NRC MODIFICATIONS

IMPORTANT SAFETY RECALL

NHTSA Recall ID 21-V-624

HEHR 6400 SERIES WINDOW VENT RECALL

Fig. 5

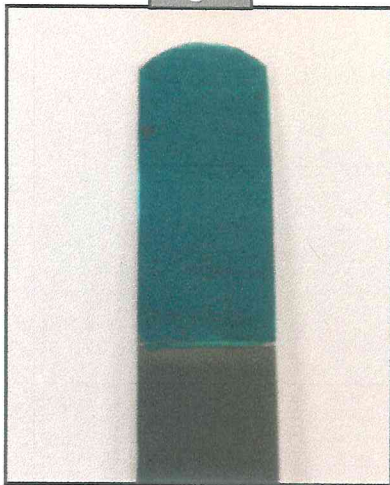
The provided gauge has a colored segment at one end (Fig. 5). Use the gauge as outlined in the instructions below to determine any possible break in the seal.

Fig. 7

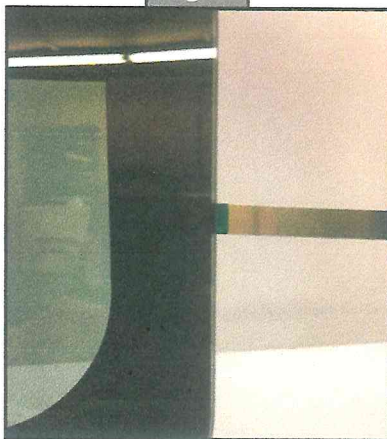
1. Be sure window is in closed position.
2. Lightly insert the gauge into the gap between the glass and the frame (Fig. 6) starting near the hinge on the exterior side of the window.
3. The gauge should stop within the colored segment (Fig. 7).
4. Continue reinserting the gauge at different points, working around the glass.

Fig. 8

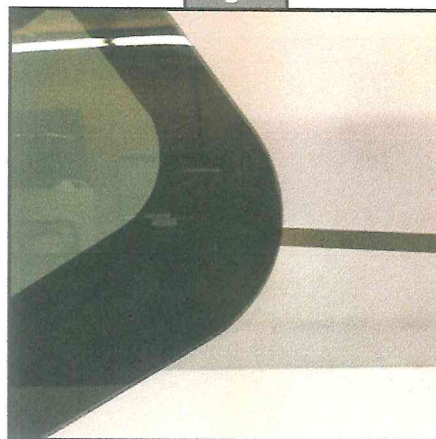
NOTE: If the gauge inserts beyond the colored segment (Fig. 8) this indicates a possible break in the seal and the vent of the window will need replacing.
